Accredited Standards Committee
X3, Information Processing Systems

Doc: X3T10.1/96a165r1
Date: September 22, 1996
Project: X3T10.1 / 1146D
Ref Doc.: SSA-PH2 rev 3
Reply to: John Scheible

To: X3T10.1 Membership
From: John Scheible
Subject: Changes to SSA-PH3 rev 3

Figure 1 - Port connection segment test load

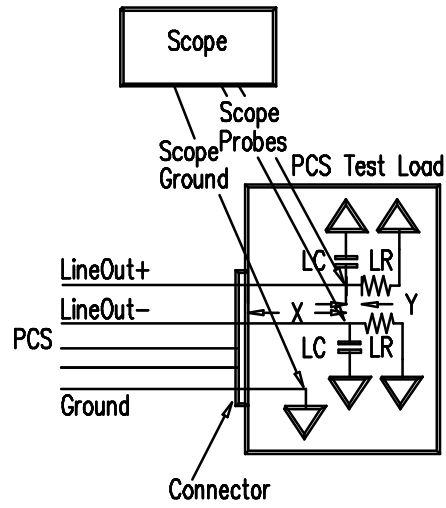
During the discussions on Port Connection Segment testing at Ithaca the Port Connection Segment Test Load was generated. There was some discussion between myself and Bill Ham as to where the scope should be connected. In the end Bills view prevailed and rev 3 shows the scope connected to the connector pins.

Since then I have done some measurements which show that the addition of even 0,4pF of scope probe added at the connector pins causes the impedance at the connector (as seen by a TDR at 375ps risetime) to fall from 137 ohms to 129 ohms. If however the same scope probes are connected at the point at which LC would appear then the impedance at the connector is unaffected. In addition, by connecting the scope probes across the capacitors, which represent the silicons input capacitance, then the signal displayed by the scope will be the signal that the silicon will see. In effect placing the scope across the capacitors removes the disruptive effect of the scope probes from the measurement.

Tests to determine the value of LC required to cause the dip in the TDR plot below 120 ohms for 375pS resulted in a value of around 2.5pF (0805 cap). As the scope probes which most seem to use have capacitances close to this value, placing this much capacitance at the connector would cause the test load with scope probes attached to fail the requirements of 7.3 as there would be two dips below 120 ohms, one at the connector and one at LC.

Figure 16 should therefore be amended to show the scope probes connected across LC.

- a) Is this correct?
- b) This requirement implies that the implementer not put LR and LC within the silicon, or that an I/O be supplied to measure this point. Do we want to specify this?

CHANGES: Change Figure 16 and the preceding paragraph as follows:

The driver test environment shown in 7.1.3 and the associated measurement procedure shall be used when setting the input signals applied at point M2. Once the input signals have been set, the port connection segment shall be connected in place of the driver test load and measuring equipment. **The Port Connection Segment test load (see Figure 1) and the measurement procedure shown in 7.1.3.1 shall be used at point M3. The Port Connection Segment test load with scope probes attached shall conform to the characteristic impedance requirements in 7.3 at its connector. The value of each of the two capacitors LC shall be adjusted such that the total capacitance of LC and its associated probe causes the impedance beyond its time point, measured from its respective Lineln to ground, to fall below 60 ohms for 360 to 375ps. Typically the total capacitance of LC and scope probe will be in the order of 2.5pF. The values of LR, X and Y in Figure 1 shall be $75 \Omega \pm 1\%$, $5 \text{ cm} \pm 5 \text{ mm}$, and $5 \text{ mm} \pm 1 \text{ mm}$ respectively.**
